Re: Proposed Water Supply Project for the Eastern and Midlands Region
in the counties of Clare, Limerick, Tipperary, Offaly, Kildare, and Dublin.

Please find attached a further submission from Waterways Ireland in its capacity as a prescribed body, in relation to Uisce Eireann's response to submissions report.

Case Reference 323980 - Water Supply Project Eastern and Midlands Region

Figure 1; 3-Day Average Lake Level: 2000-2025

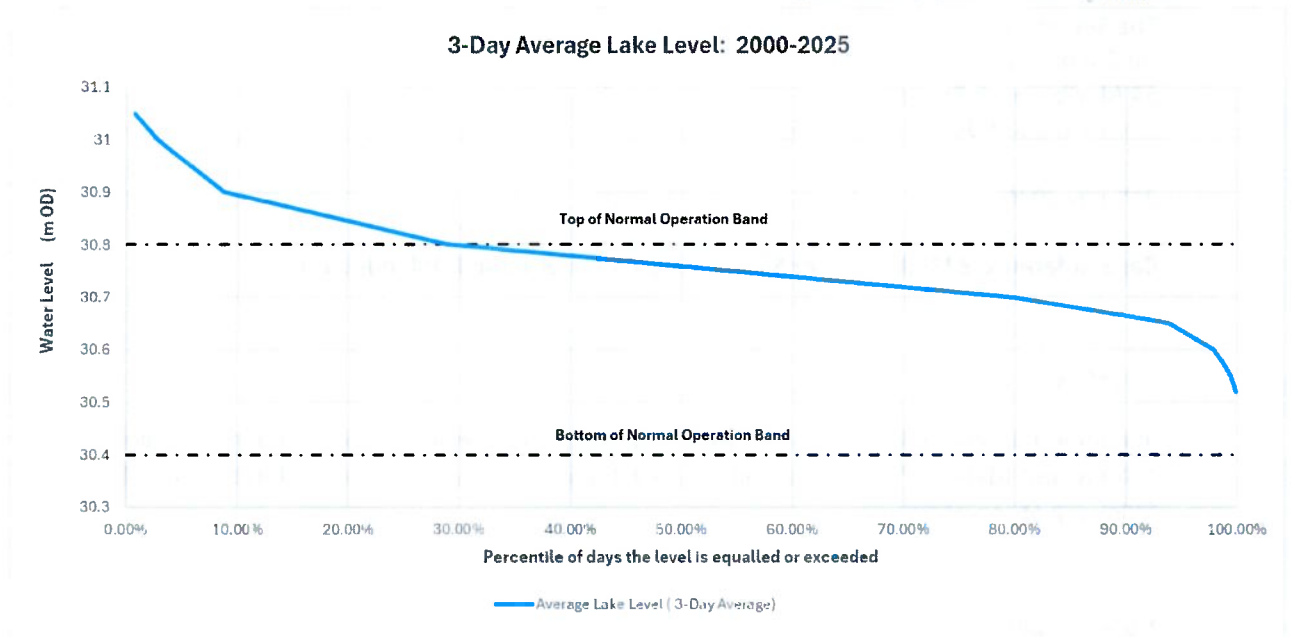
Waterways Ireland has undertaken a review of water levels from 2000 to 2025 to ascertain the typical water level variation. For consistency with Uisce Éireann's analysis, a 3-day moving average lake level has been used. As shown in Figure 1, the full operation band is rarely used in practice; a lake level value of 30.60 mOD is exceeded 98% of the time. Further analysis of the level records indicates:

- Only 2 days were recorded below 30.52 m OD in the 25-year period during the navigation season (April to October).
- The lowest water level experienced in the last full ten years (2016-2025) during the navigation season (April to October) was 30.60 mOD.

This confirms the requirement for a navigation assessment as requested in our previous submission "as there is limited to no sustained period where the average lake level is below 30.60mOD during the navigation season."

Figure 2: WSP Hydrological Model: Simulation of the 2018 Drought Including Climate Change: i) Without WSP, ii) WSP = 154Mld, iii) WSP = 300Mld (Adapted from Uisce Éireann, Water Supply Project EIAR, Appendix A9.1, Annex A, Image 2.9)

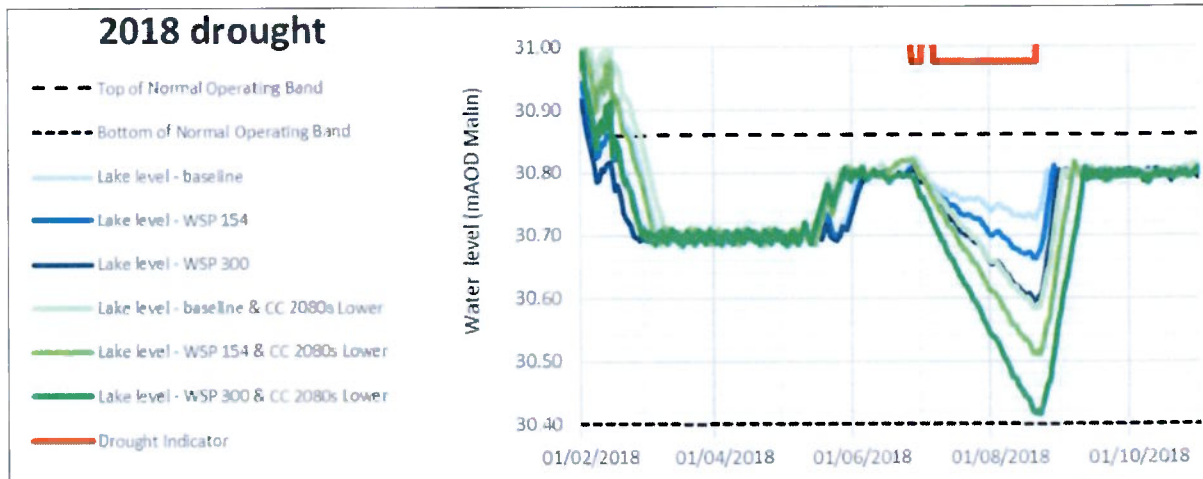
We note that the projected change in water levels “allowing for worst-case climate change” appears to equate to the impact of the full implementation of the WSP on its own (see Figure 2):

- The reduction from the baseline due to “worst-case climate change” is approximately 140mm (see legend for *Lake Level – Baseline & CC 2080s Lower*)
- The reduction from the baseline due to full implementation of project is also approximately 140mm (see legend for *Lake Level – WSP 300*)

Therefore, rather than conflating the two issues, Waterways Ireland maintains that the combined, compounded effect of both the WSP's full implementation and climate change requires a navigation assessment.
